SSD Submission Response

UNSW - Biological Sciences Project
May 21, 2015

prepared for Brookfield Multiplex
by Black Beetle pty ltd

FIG.1.0 - SITE THROUGH LINKS AND PROPOSED BUILDING ENTRANCES

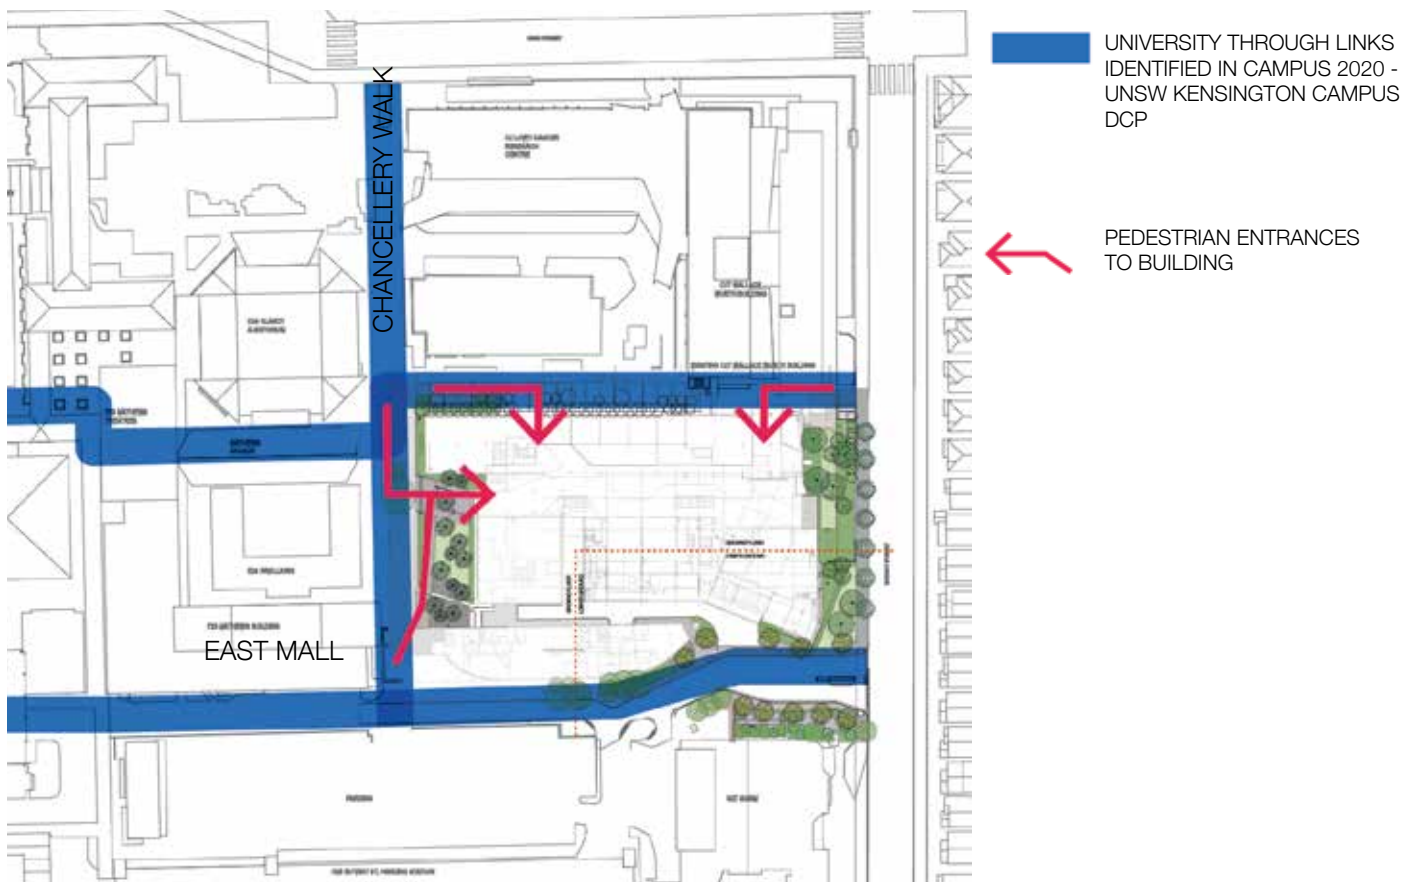
The existing underpass through the Samuels Building (F25) does not provide a clear and dignified route towards the northern portion of the campus and significant open space areas such as the Michael Brit Gardens. The proposal should provide a greater emphasis on the pedestrian access at the intersection between the Chancellery Walk and East Mall and in effect compliment the ceremonial importance of the Chancellery Forecourt areas. Furthermore, the proposed ramp on the western side of the southern wing of the Biolink Building (D26) would benefit from a site-link of a more appropriate width (eg. 6 metres or greater in width) in order to provide greater definition to the circulation spaces and when servicing a greater number of students/staff entering and exiting these areas. The ramp will in effect act as the critical path to buildings D26 and E26 given it offers the shortest distance from the East Mall pedestrian pathway. The softening of the built form by providing landscaping elements along the eastern edge occupies a large portion of the Chancellery Walk and reduces the legibility of the pedestrian footpath movements to the northern side of the campus.

The intersection between the Chancellery Walk and East Mall is part of the overall University master plan and way finding strategy.

Black Beetle disagrees with widening the path to 6m and propose a compromised 3m wide path is (see attached) in order to maintain an active / passive green pocket space amongst the existing hardscape pedestrian links (Chancellery Walk and East Mall) and buildings. The 3m path is significant and should read as a secondary accessible path to the building entrance rather than the main pedestrian through link for the University, in addition the Chancellery Walk is also an overland flow path that cannot be impeded. This green space is the forecourt to the building and is designed to activate and encourage staff and student use, it also provides students and staff with an extension of the internal informal learning and study space and not just a pedestrian access way. The proposal does not erode or affect the existing pedestrian pathway or sight lines along Chancellery Walk. Similarly, the proposed landscaping does not impact on the eligibility of the western entry to the building.

FIG.2.0 - EXTRACT FROM CAMPUS 2020 - UNSW KENSINGTON CAMPUS DCP FIGURE 5.6A

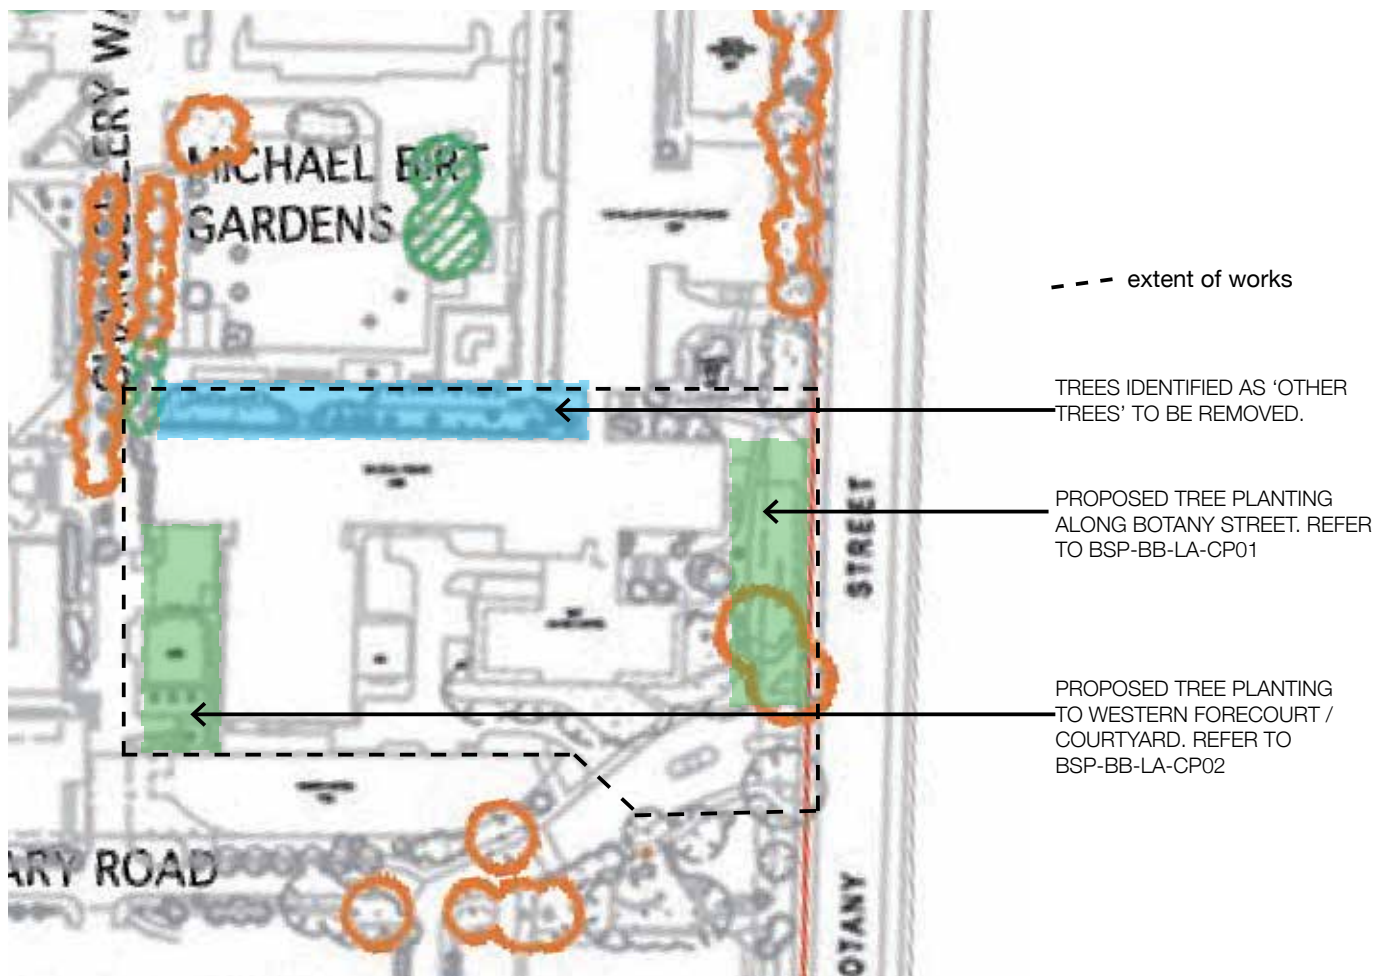
Part 4.2.5 refers to the existing trees to the north-western corner of the Biolink Building (D26) which are identified as 'highest retention priority' as per figure 5.6(a) and the northern portion of the Biolink Building as 'landscape tradition areas - preserve within guidelines' as per figure 5.6(b). The statement of environmental effects and attached arborist report details the removal of 31 trees along the northern portion of the Biolink Building (D26) to accommodate new decking and retail/student services component.

The trees identified as 'highest retention priority' and 'high retention priority' as per figure 5.6a have been retained, trees proposed to be removed are identified as 'other trees'. Note the majority of these trees to be removed are weeds (Umbrella Trees), which can be removed without consent and are classified as invasive environmental weeds.

The proposed selection of palms (*Livistona australis*) to the western courtyard provides a continuation of the existing palms (highlighted as 'high retention priority' in figure 5.6a). It also provides an opportunity to establish a significant grove of palms along the Chancellery Walk, supporting legibility of this entry.

FIG.3.0 - EXTRACT FROM BSP-BB-LA- CP03.

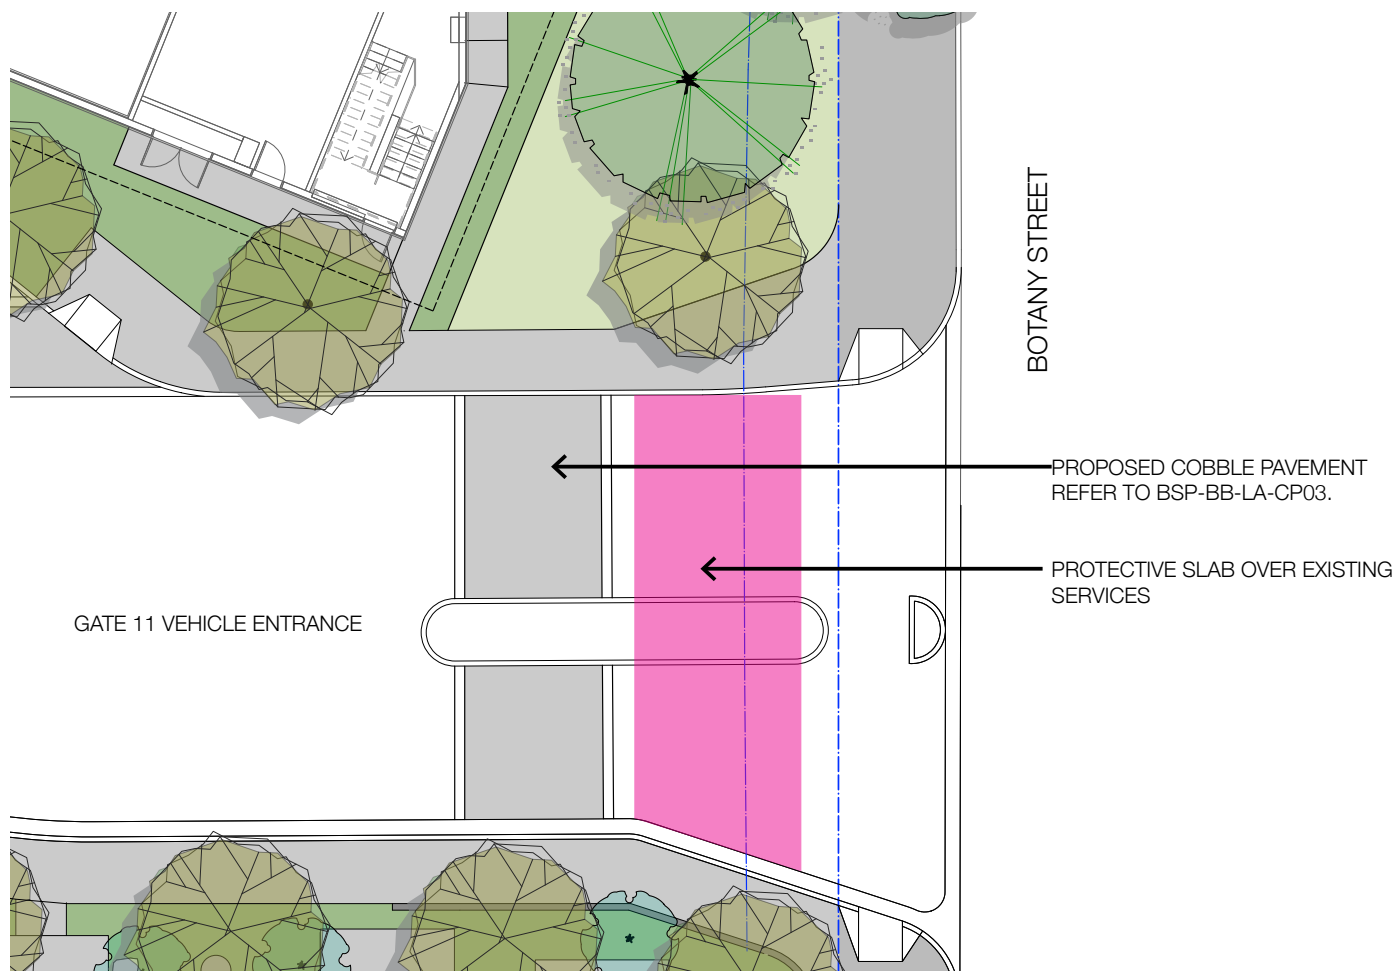
In line with previous suggestions regarding improved legibility and activation of campus gateways at Botany Street, it is recommended that differentiated threshold treatment at Gate 11 is introduced in order to not read as a public road going through the campus, and to provide a continuous and safe pedestrian footpath.

A differentiated treatment of cobblestones has been proposed as part of the Gate 11 enabling works to replicate the cobbled pavement at the existing Gate 11. (refer to FIG. 3.0 below). It has also been advised from the structural engineers it can not be brought forward towards Botany Street due to the concrete protective slab to be installed over existing below ground services in this location. The proposed location matches the existing treatment at Gate 2 of the University.

PROJECT	Drawn GB/IK Architect Authorised IK/GB Client Brookfield Multiplex	Date 24.10.14 Scale 1:200 @ A3 Status For Coordination
DRAWING TITLE	JOB NUMBER BB 1090	DRAWING NUMBER / ISSUE BSP-BB-LA-CP01 / P22

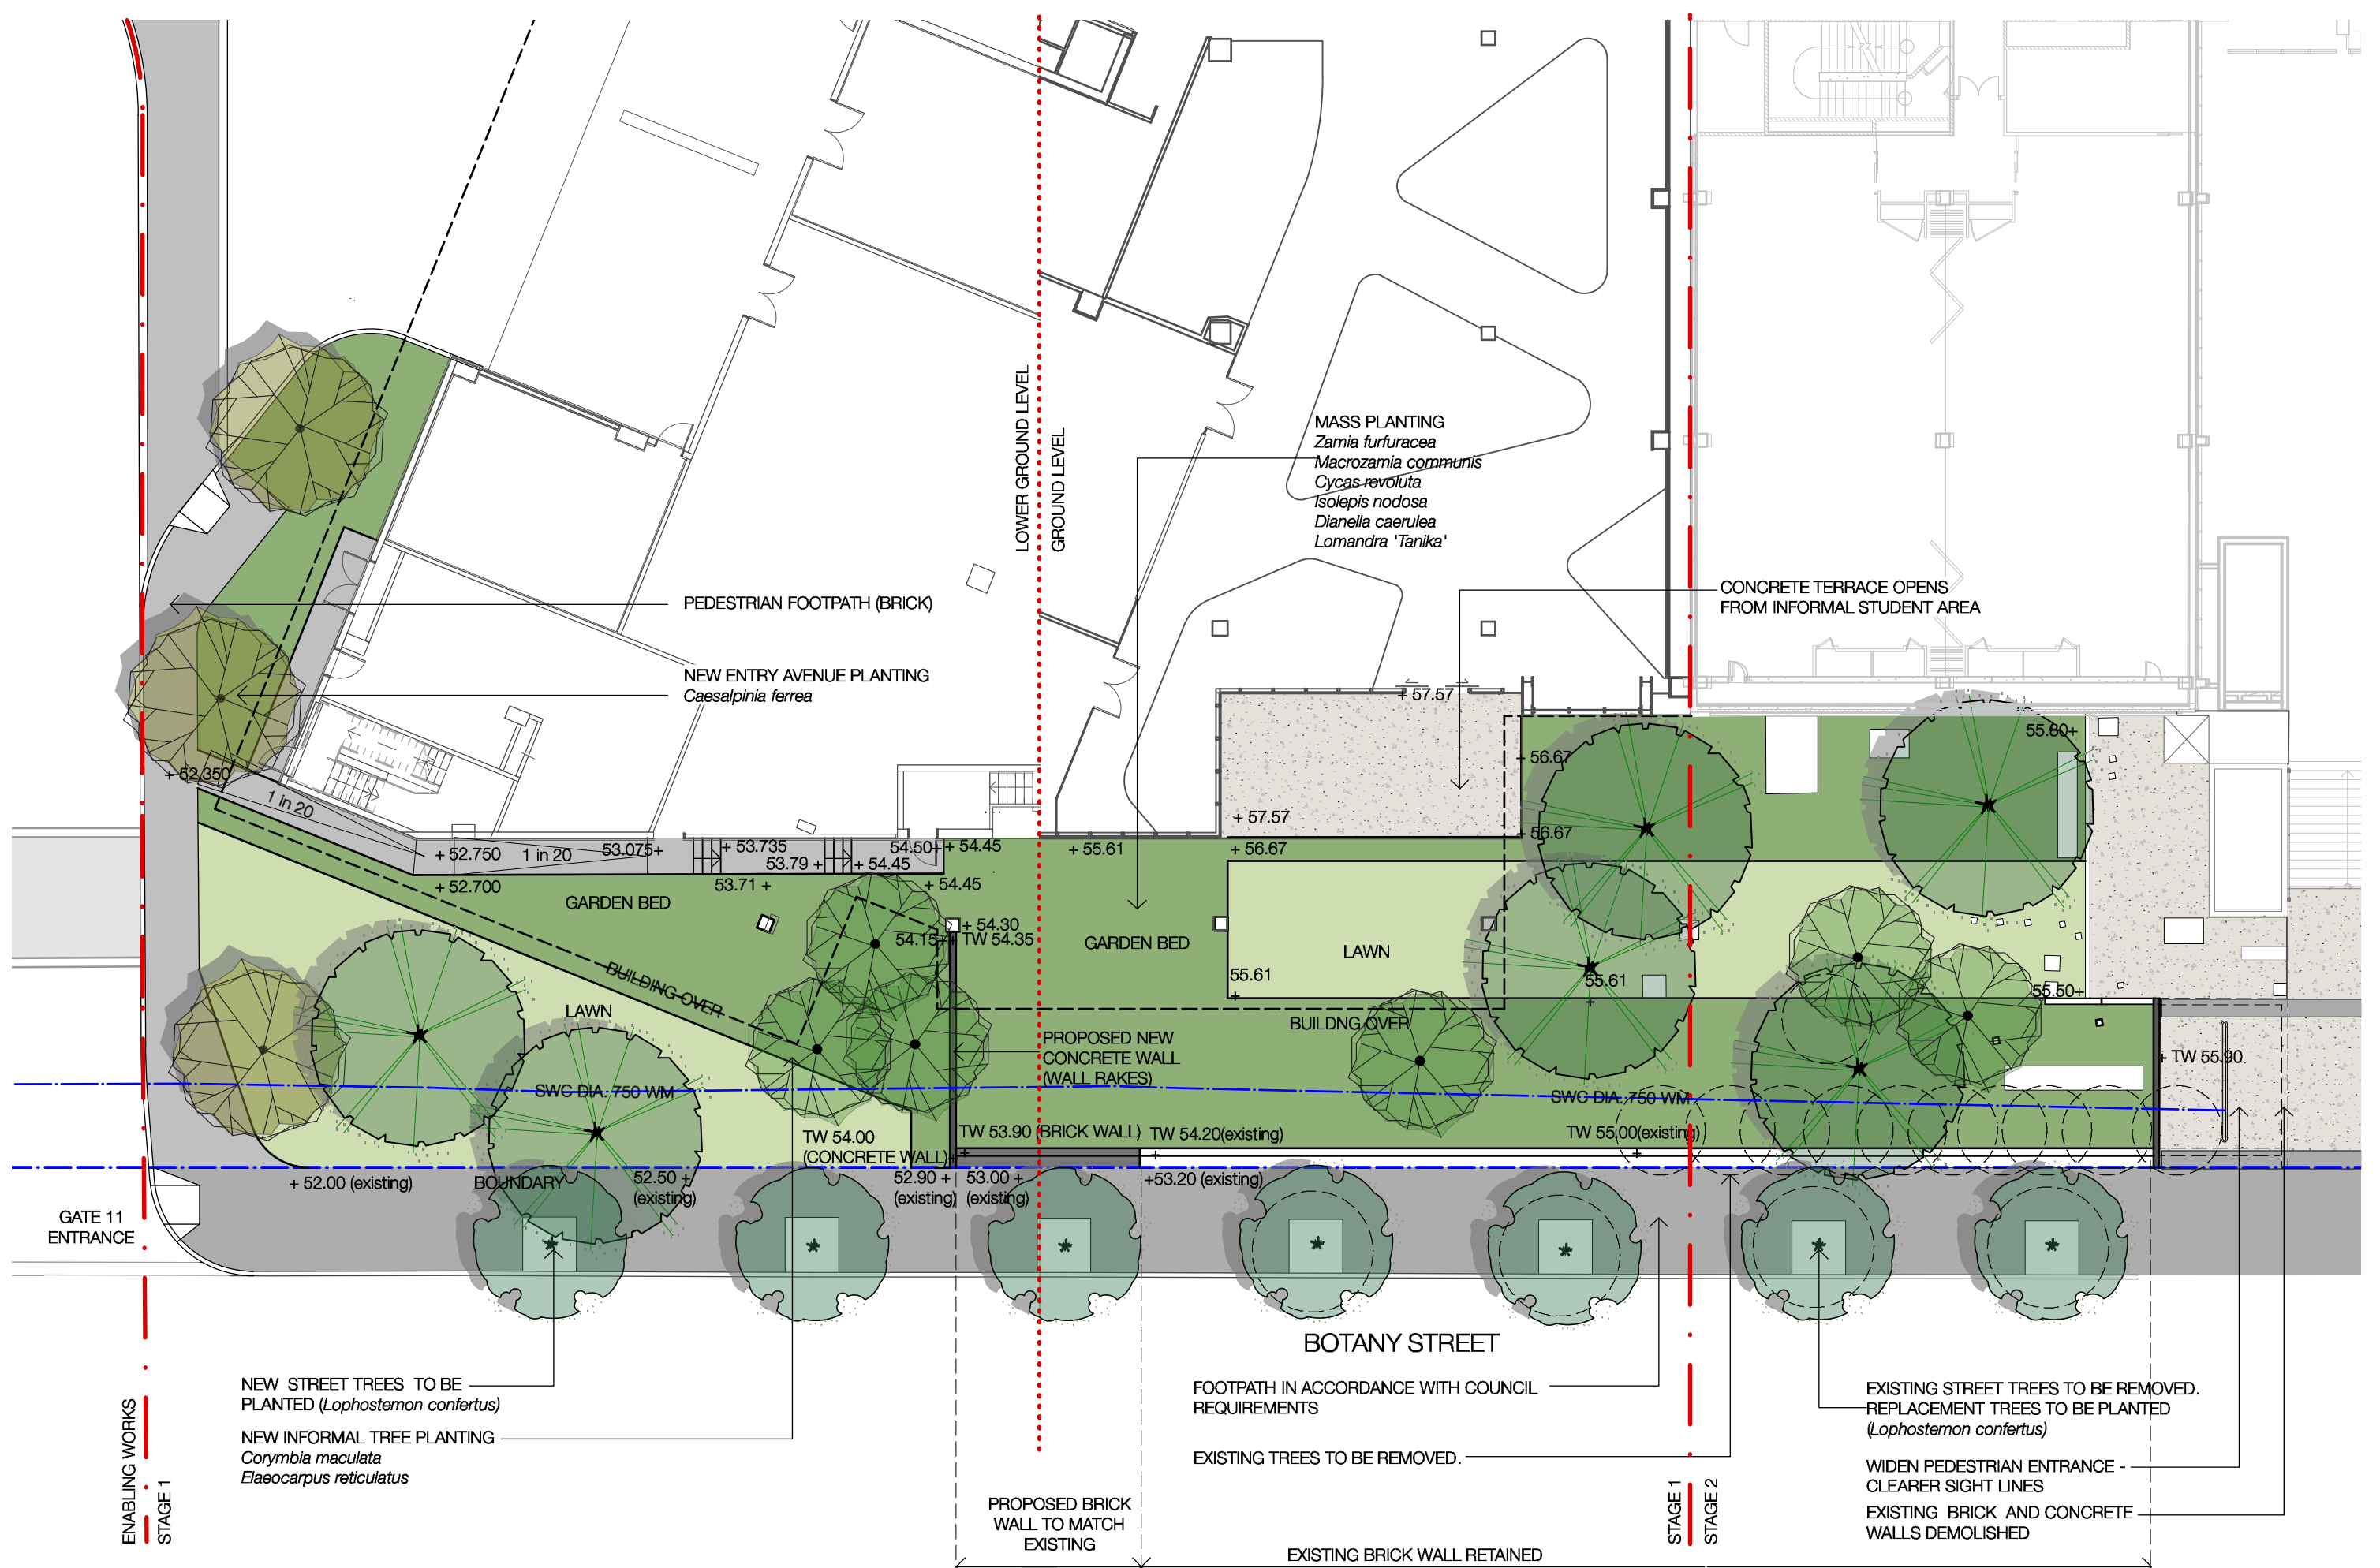
CP01 changes as follows:

- Reduction of terrace
- Inclusion of lawn on upper terrace
- Removal of concrete bleachers
- Retention of existing brick wall along Botany St boundary
- Removal of additional path through lawn on lower terrace
